Dare County ABC Store - Buxton

Addendum No. 3

June 07, 2023

Title: Structural Details

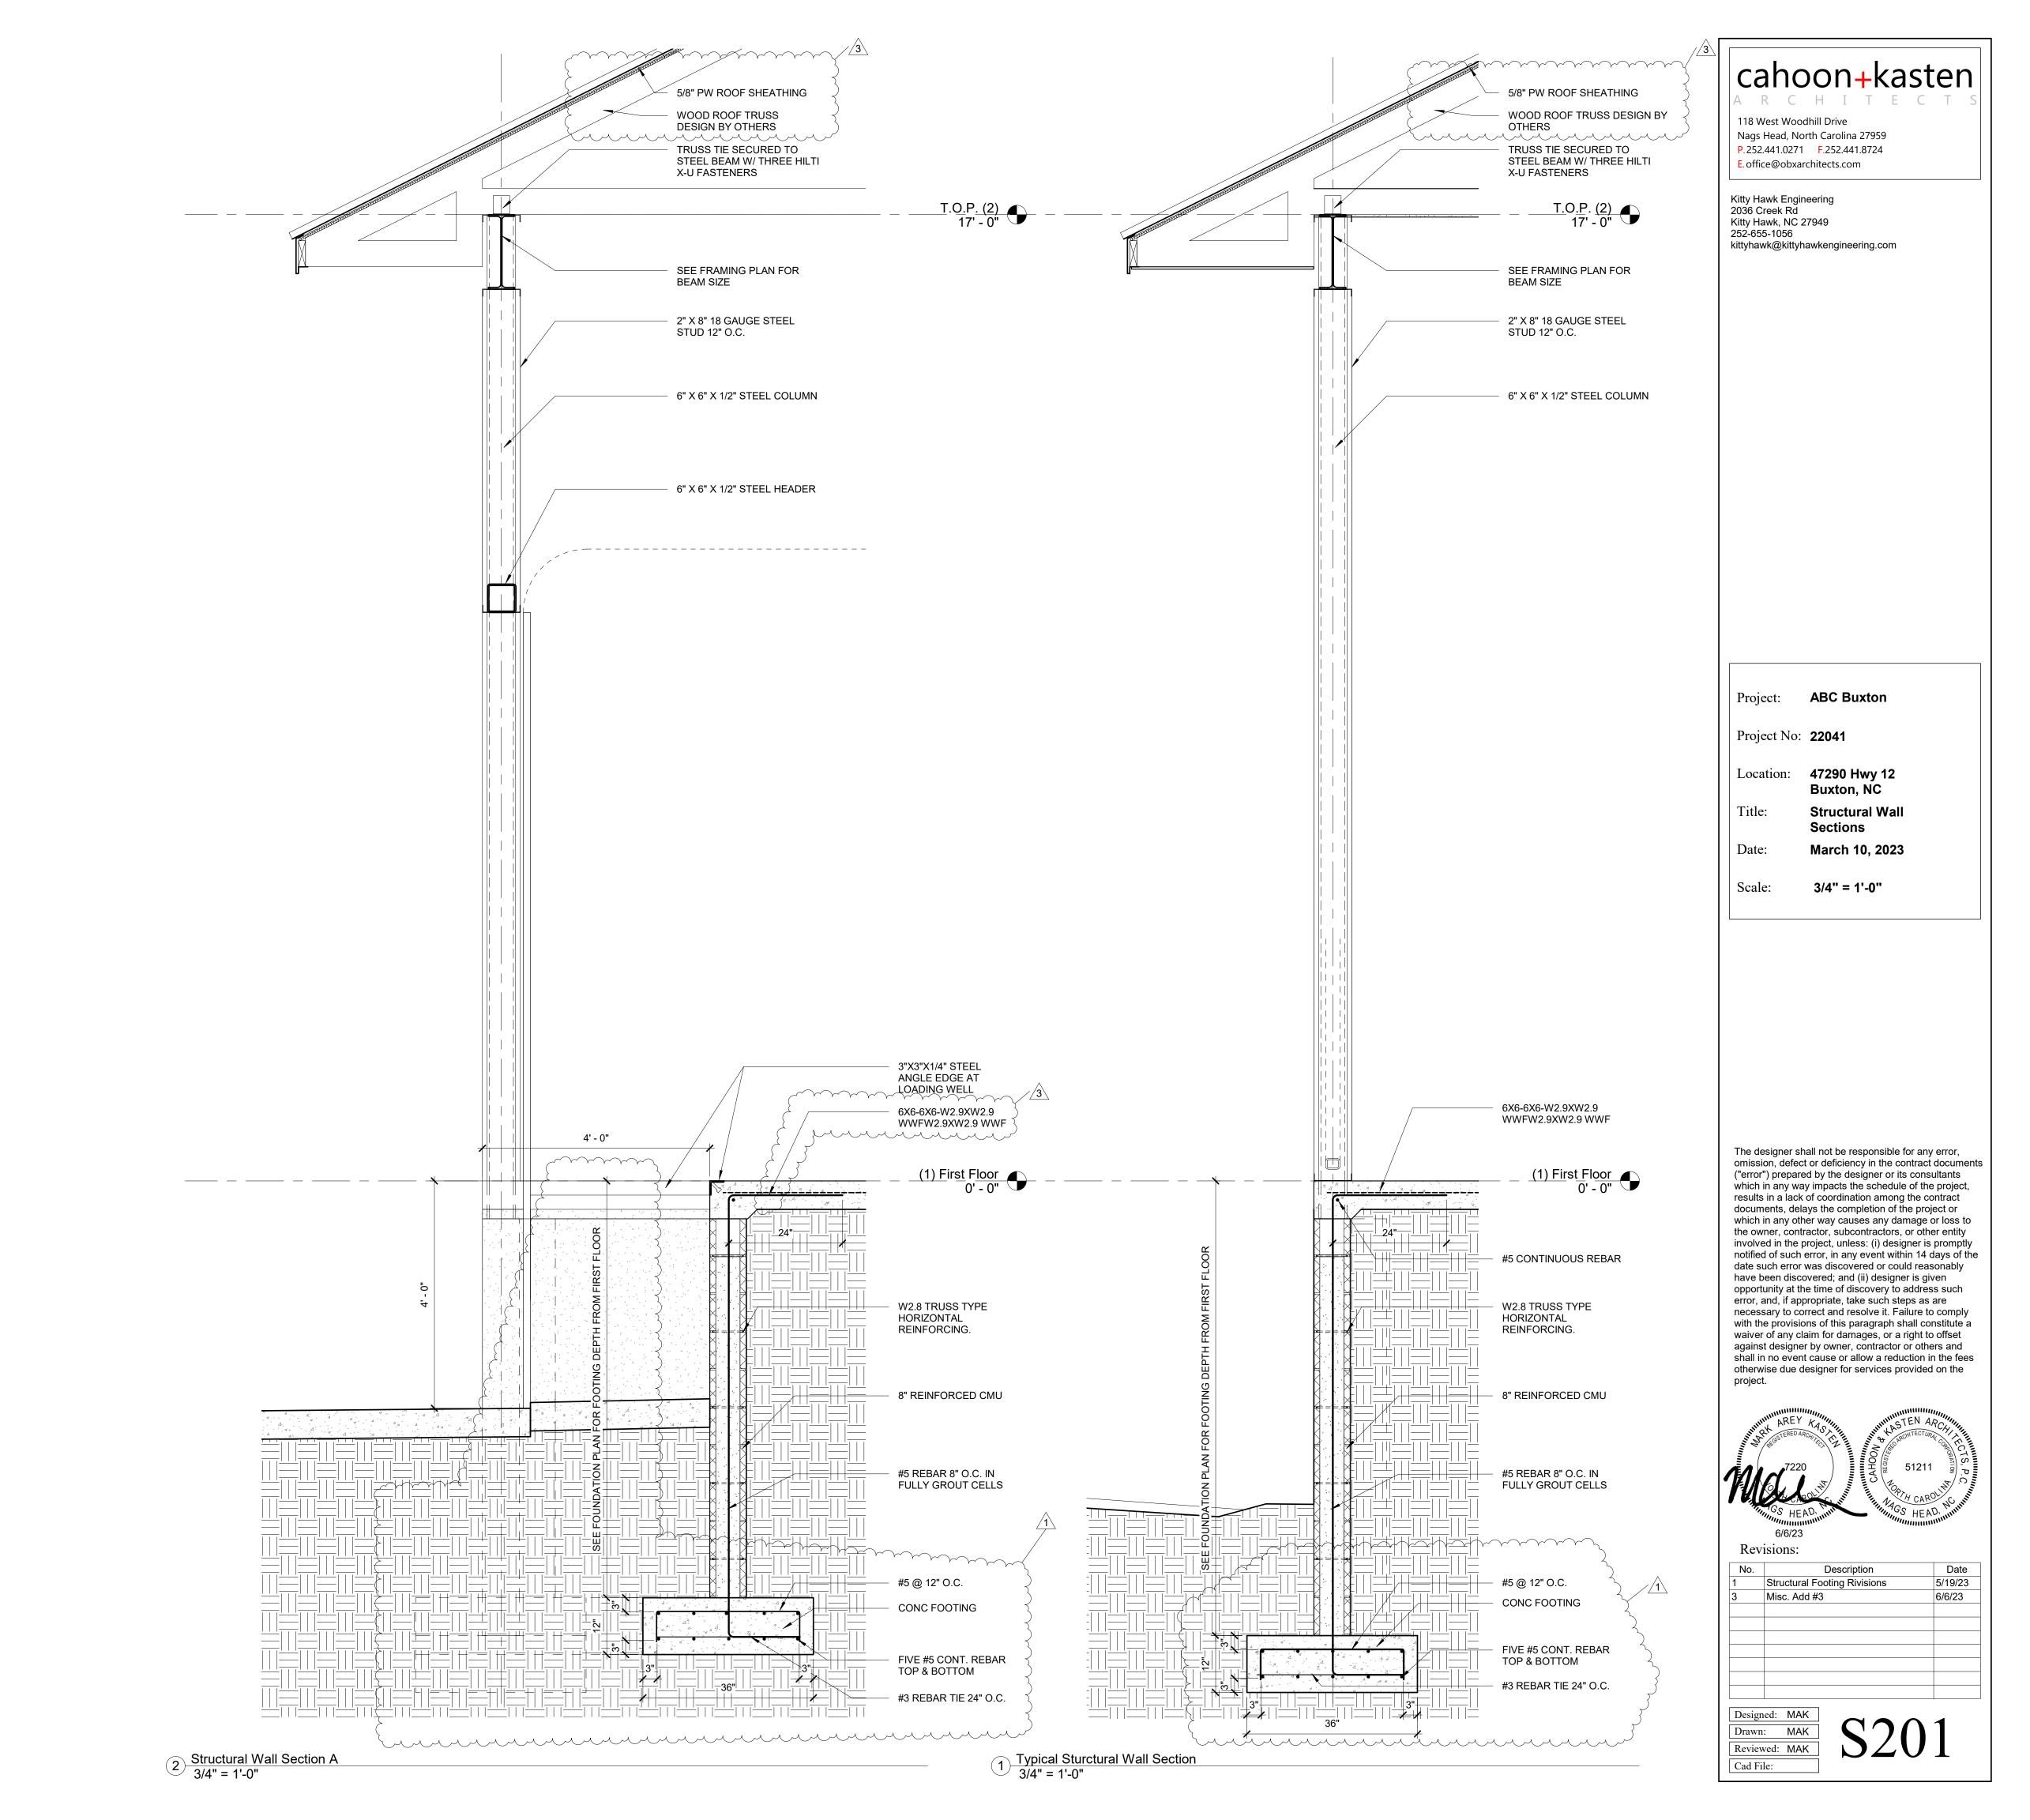
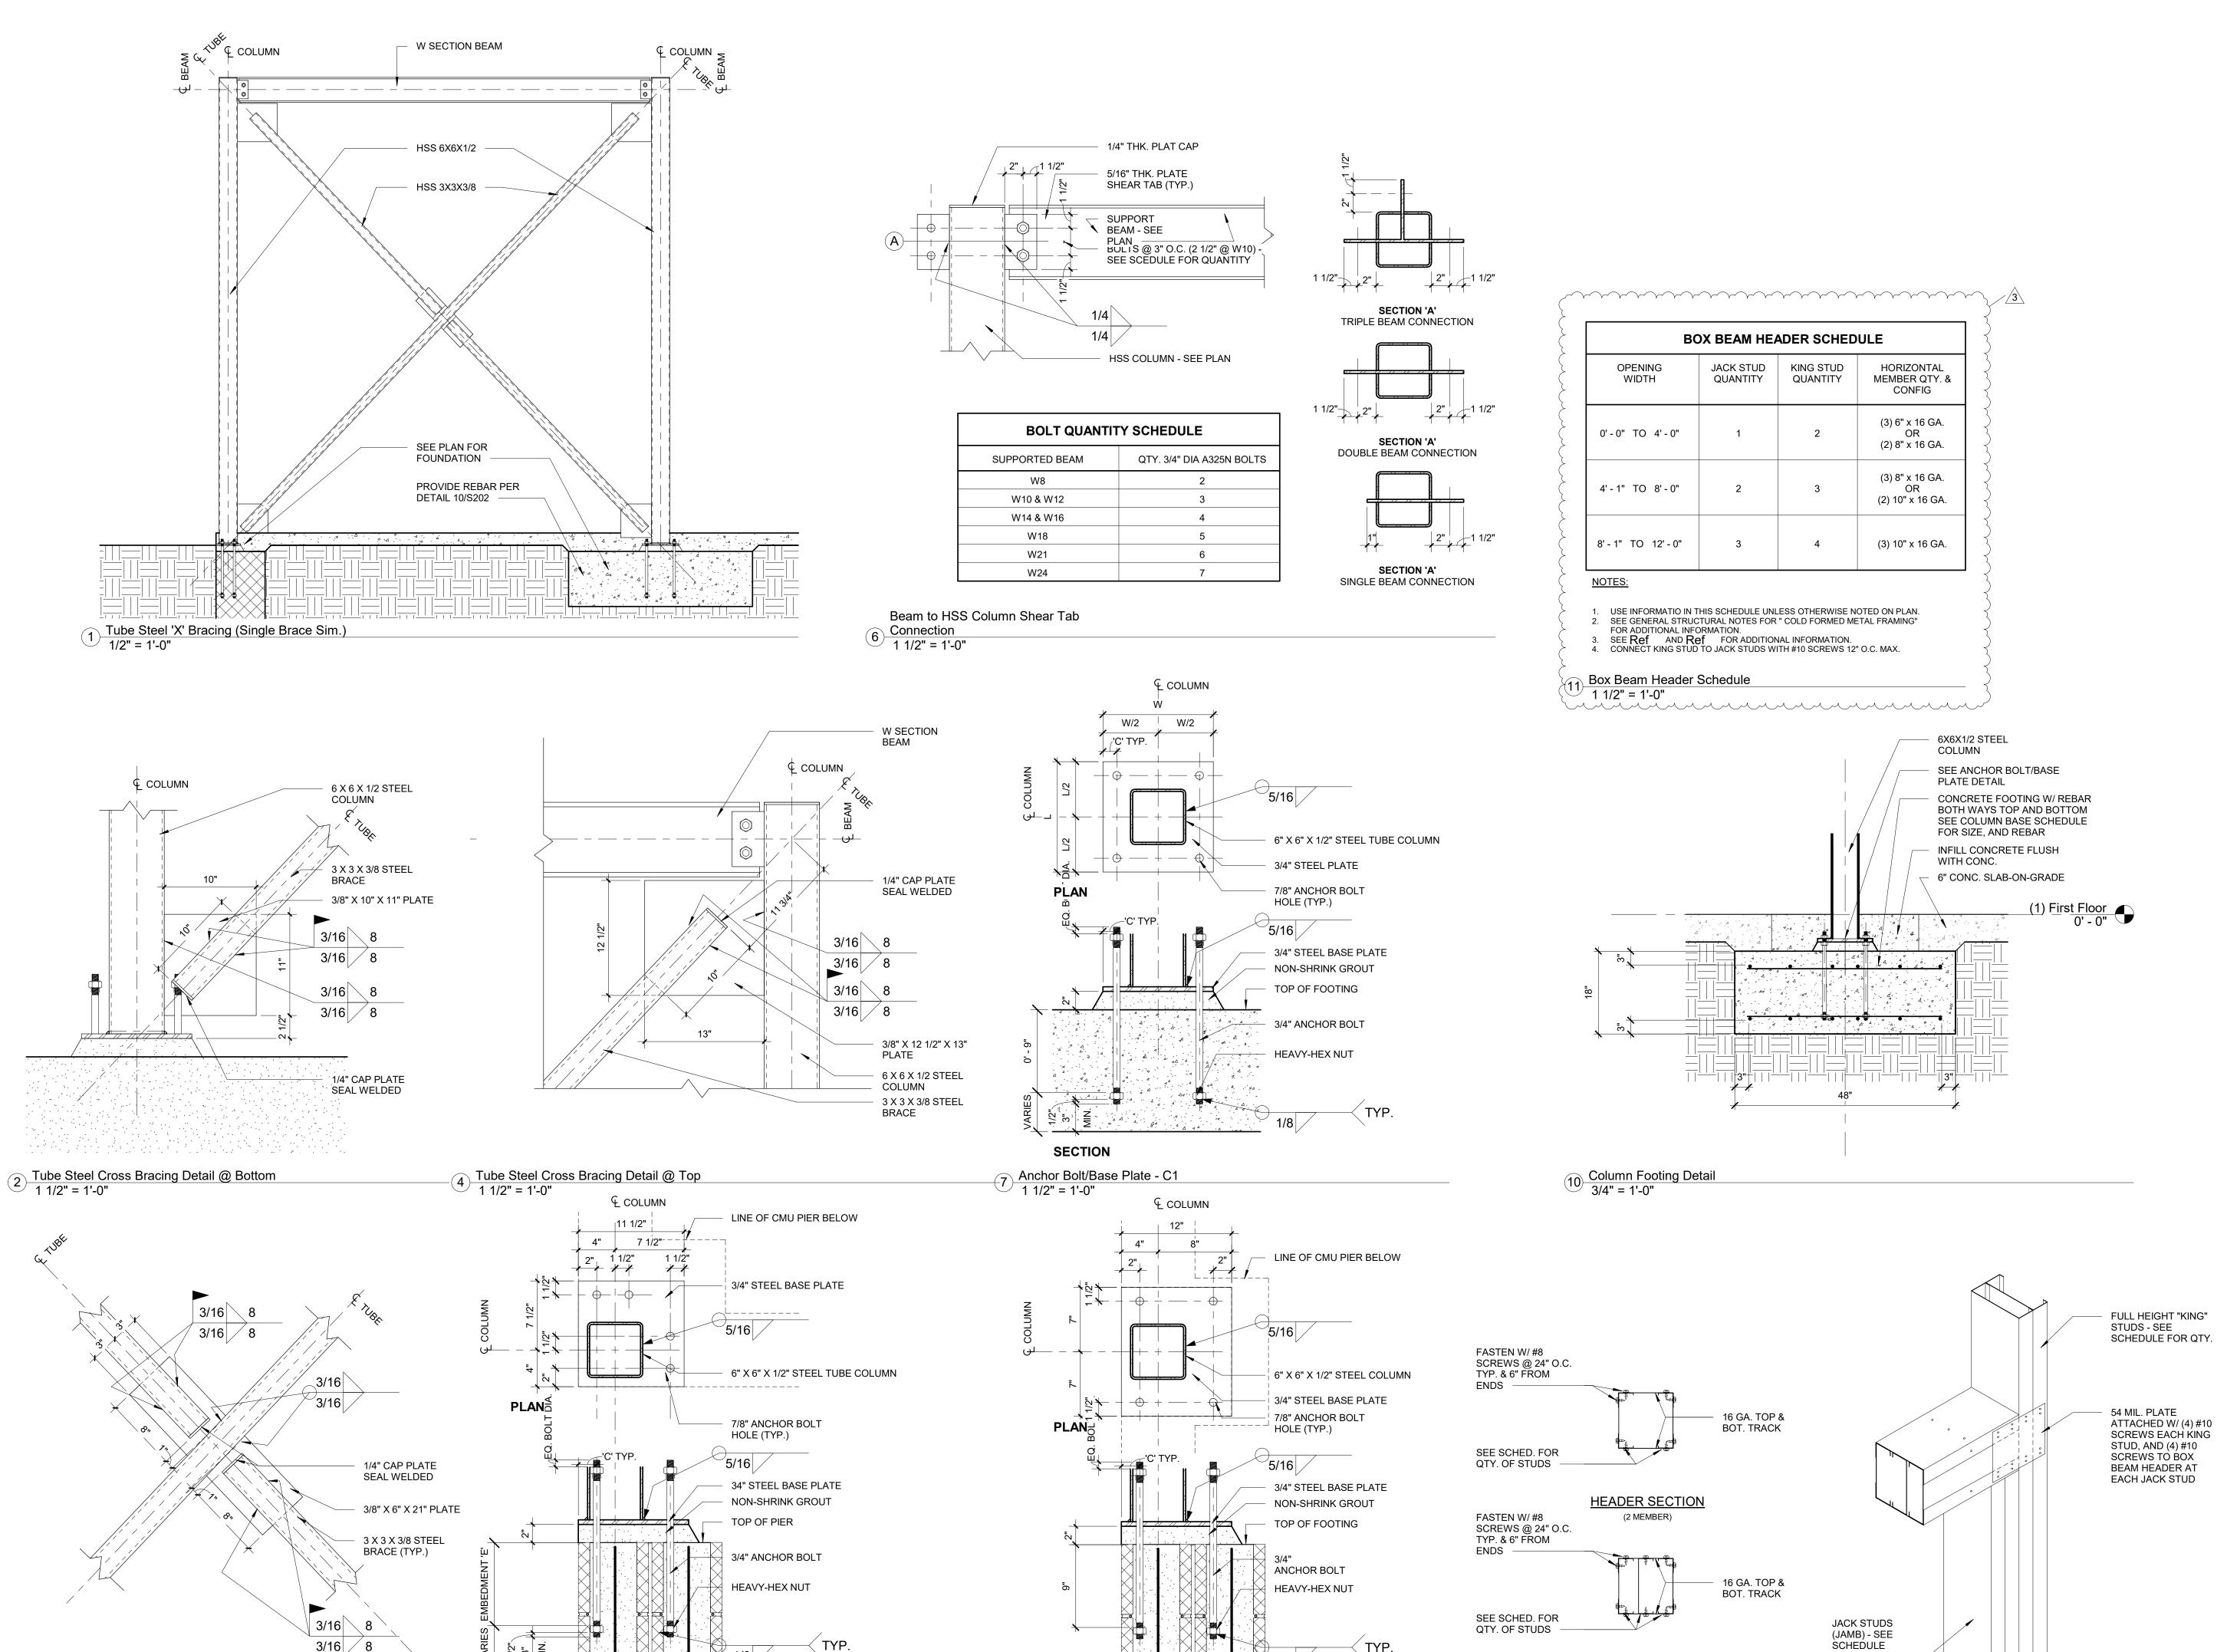
- 19. Detail 9/S202 indicates a Schedule for the Jamb Studs. The Schedule has been added to sheet S202.
- 20. Beams below the roof trusses will have an 8" metal channel top and bottom to support GWB. Details have been added to sheet A502 demonstrating this.
